ADDENDUM #1

PROJECT NAME: SCCAD Headquarters

CLIENT NAME: St. Charles County Ambulance District

PROJECT NO.: 18007

Project No.
18007
Sheet No.
A145
Date
12/02/2019

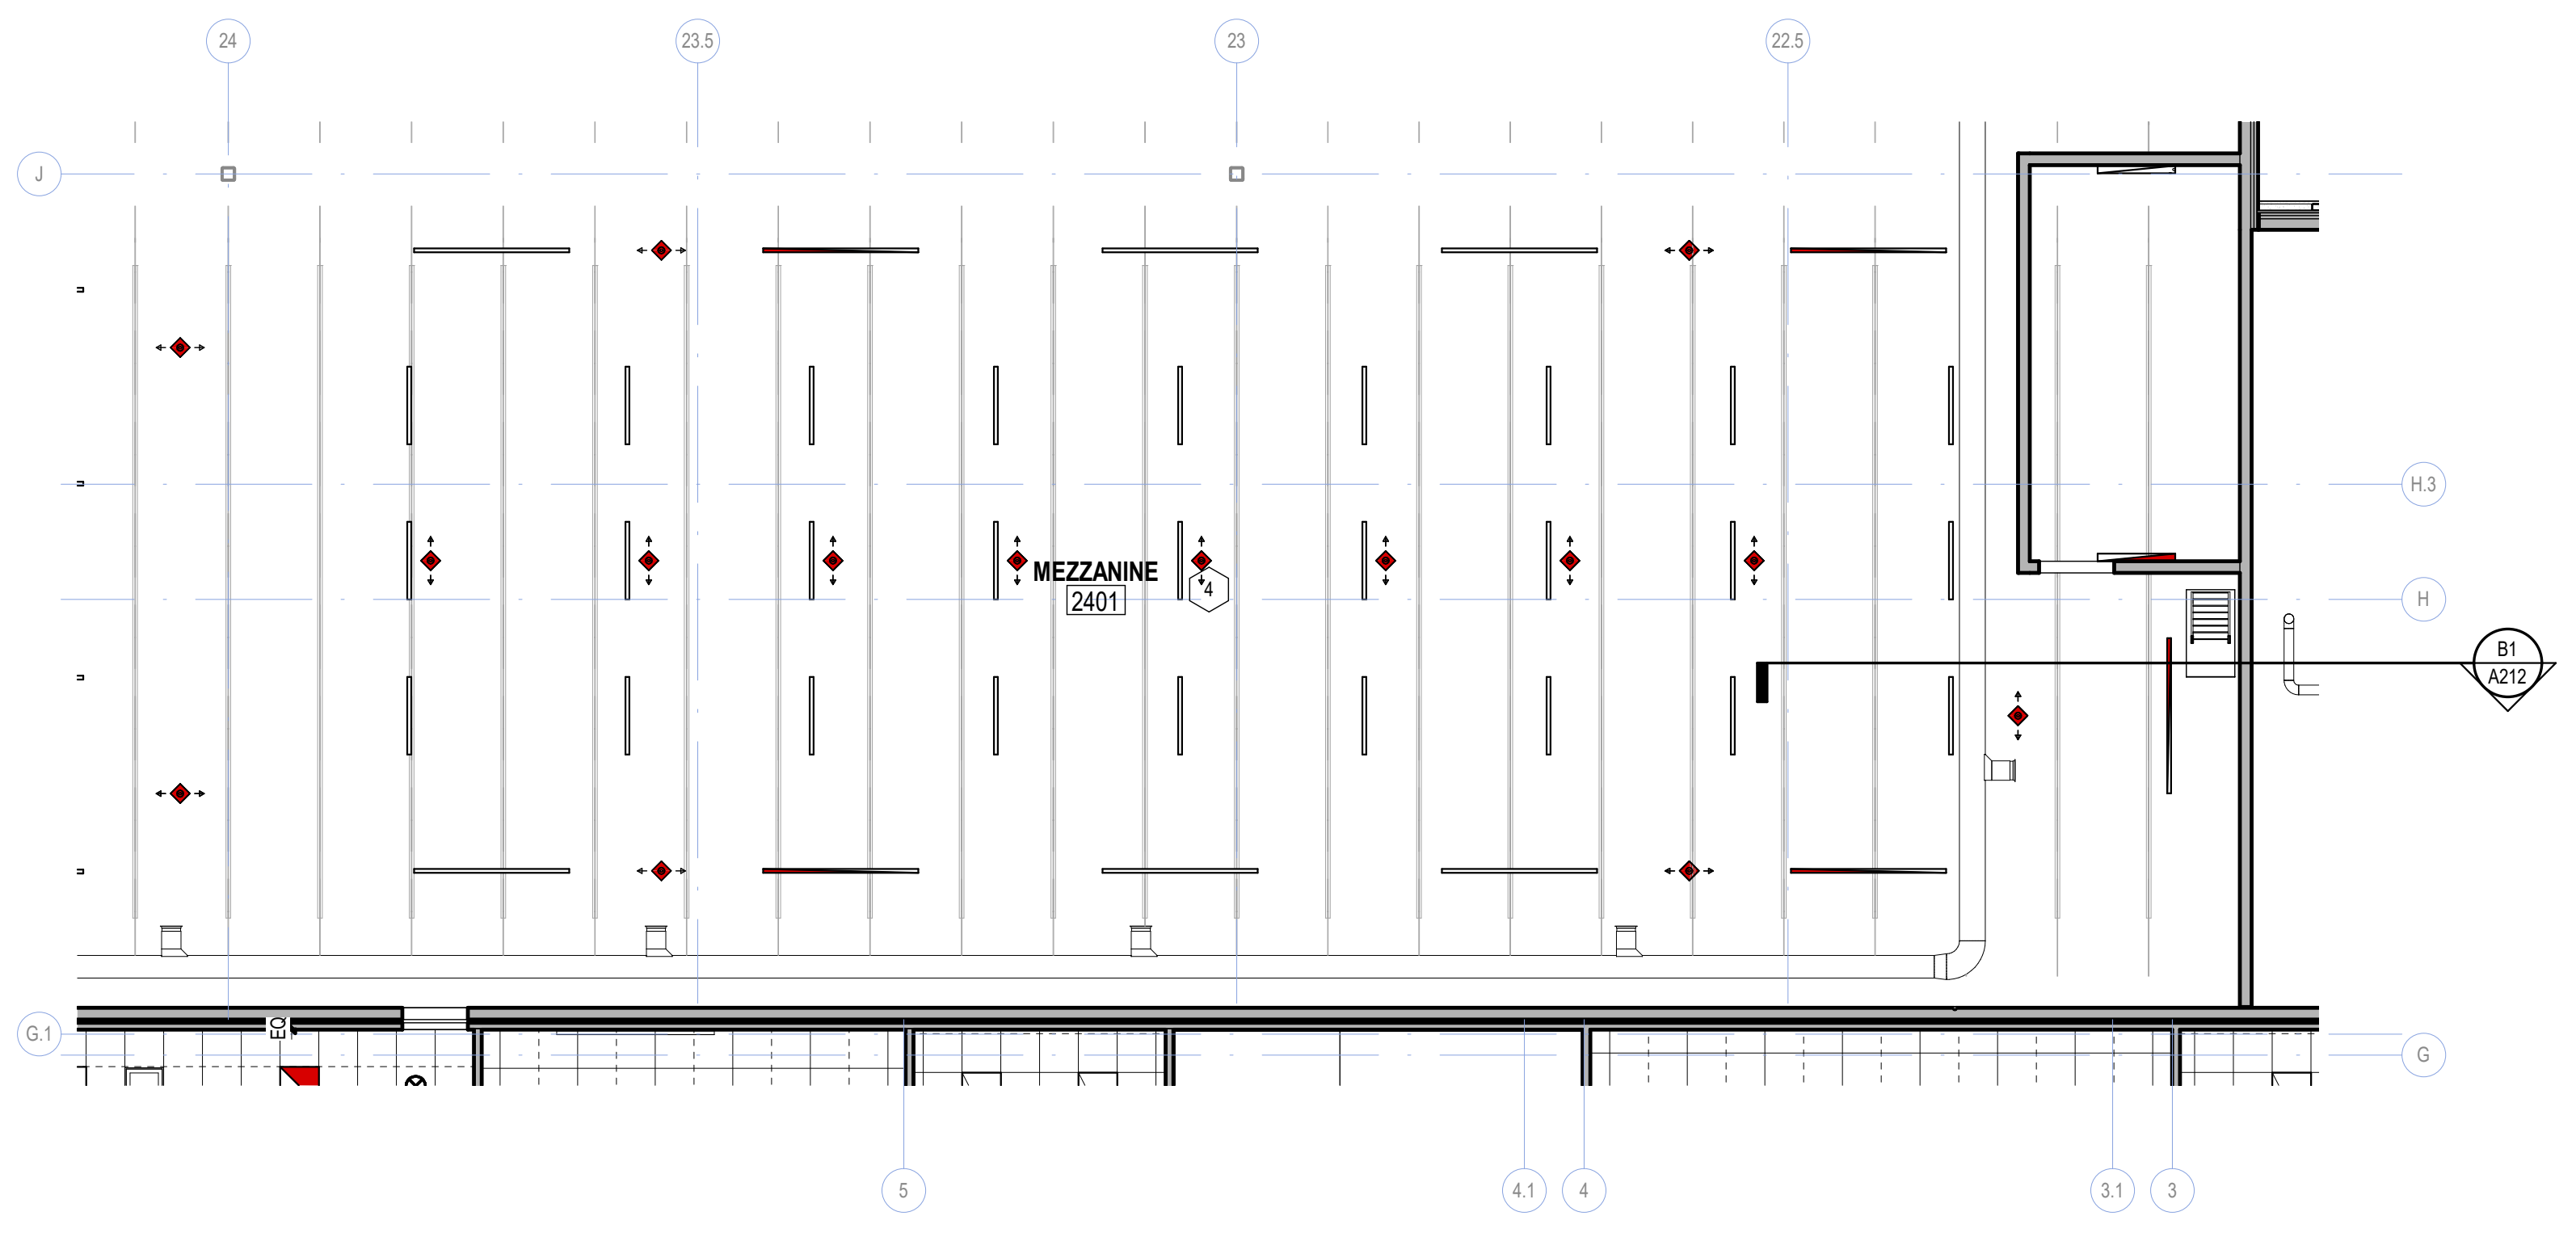
SHEET A145 – RCP Operations

1. Detail 1 L02 RCP - Operations

- REVISED – Area of RCP plan
- DELETE - Detail B6

Sheet No. **A202**

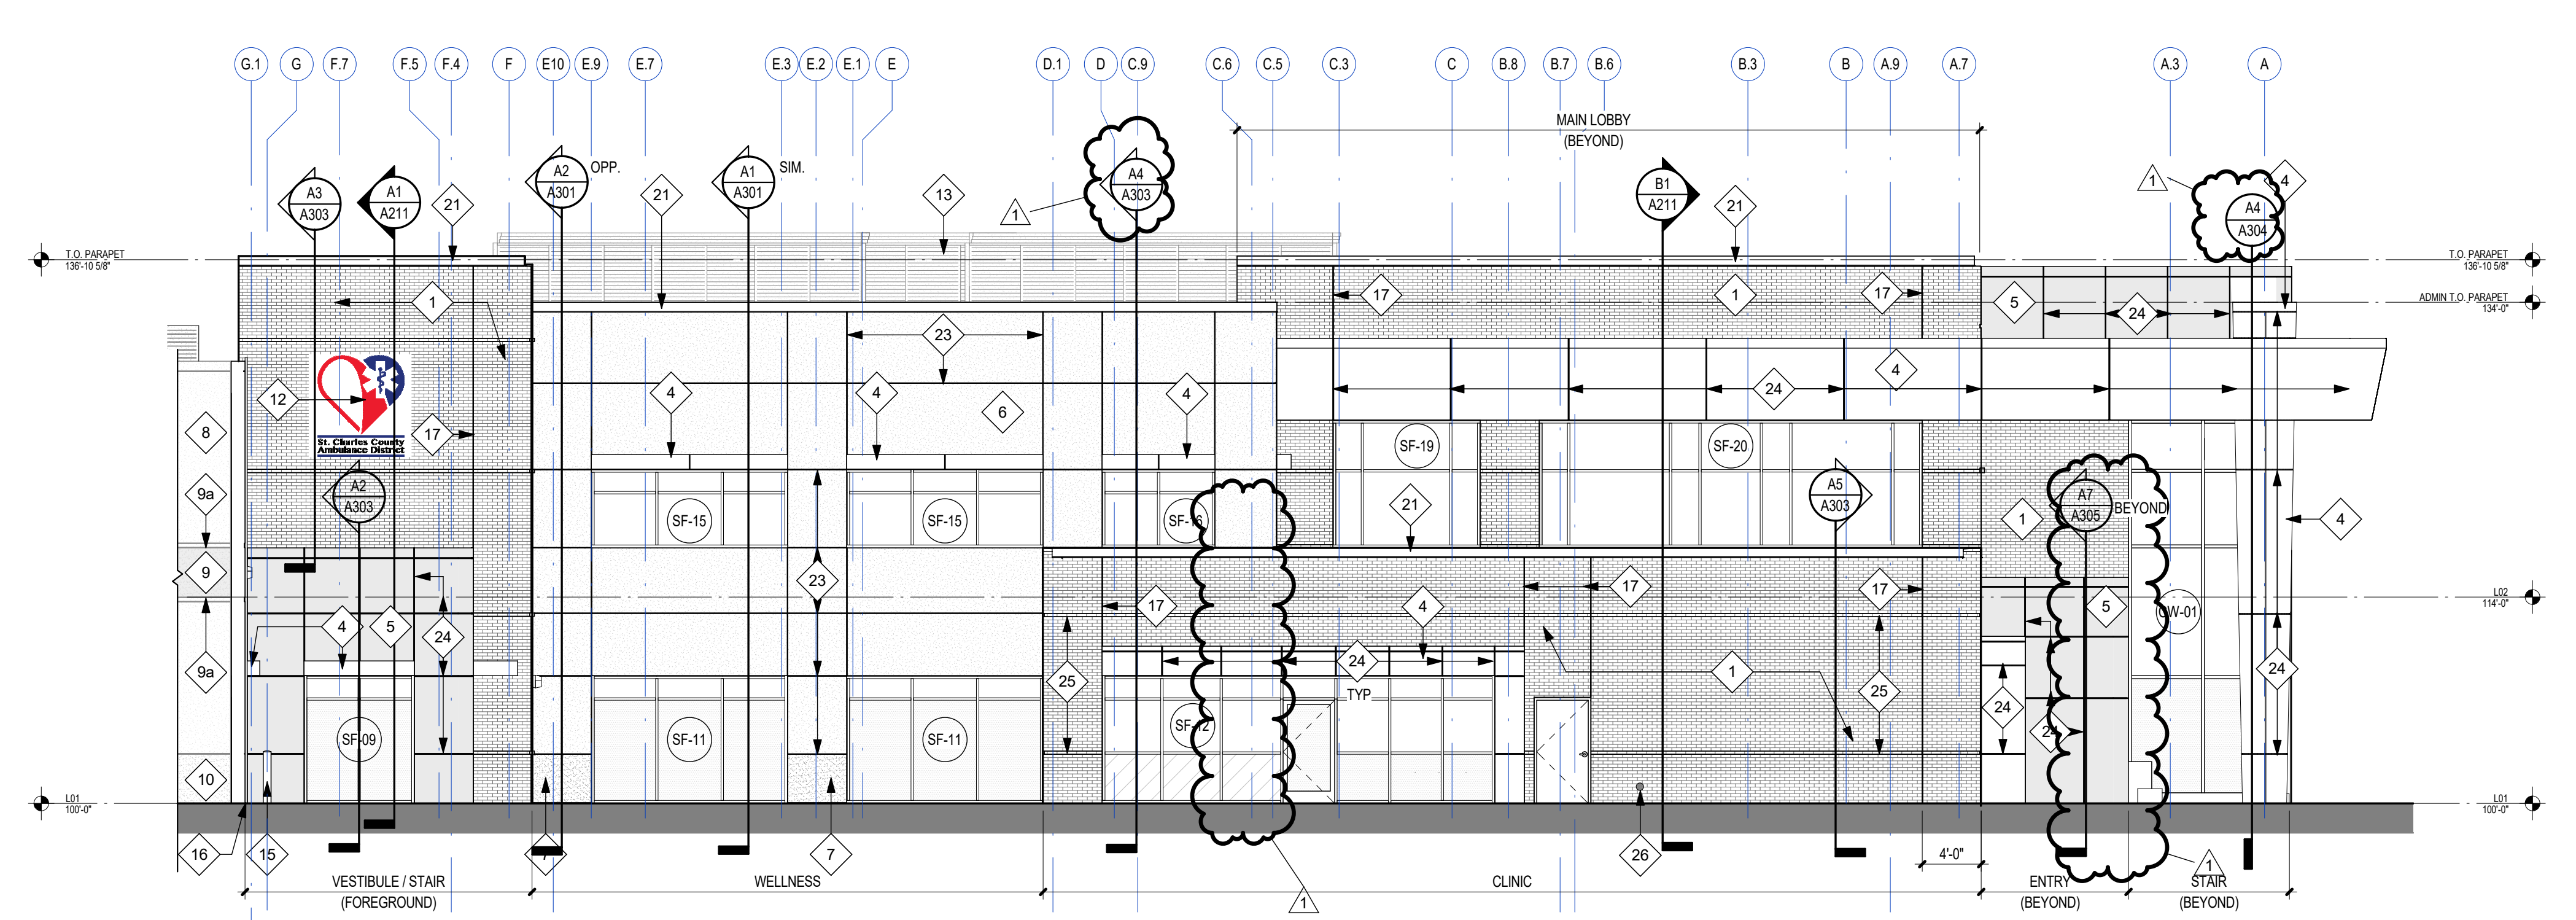
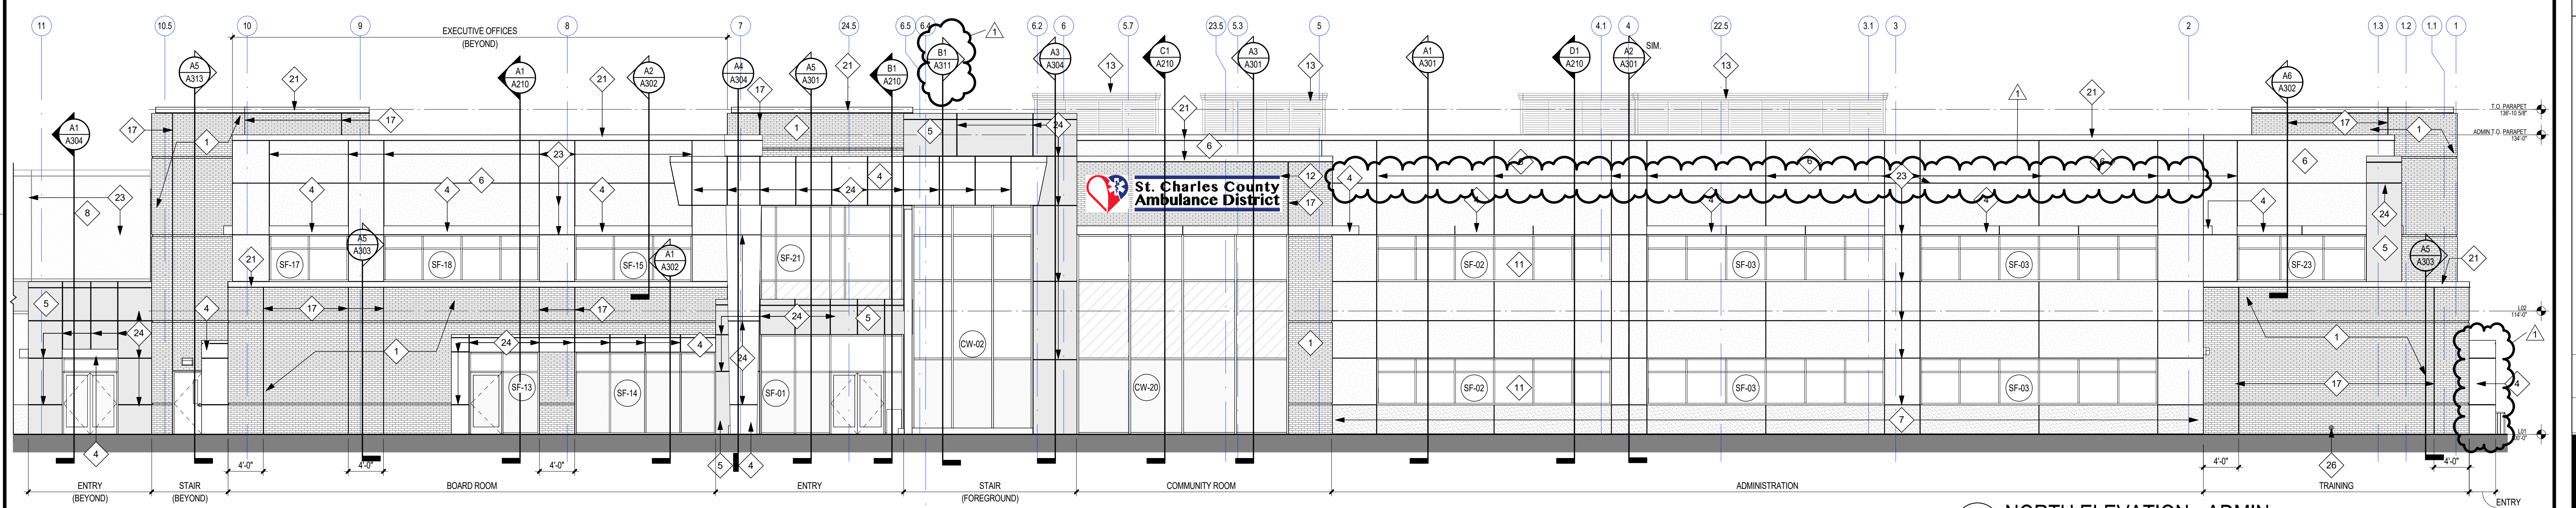
SHEET A202 – Enlarged Exterior Elevations

1. **A1 – North Elevation – Admin.**
 - ADD – Wall section
 - Revise – Horizontal reveal at Administration
 - Revise – MCM panel depth at Training 4 entry
2. **B1 – East Elevation – Admin.**
 - REVISE – Misc. wall section tag
 - ADD – Wall sections
3. **D1 – West Elevation – Admin.**
 - ADD – MCM panel reveal
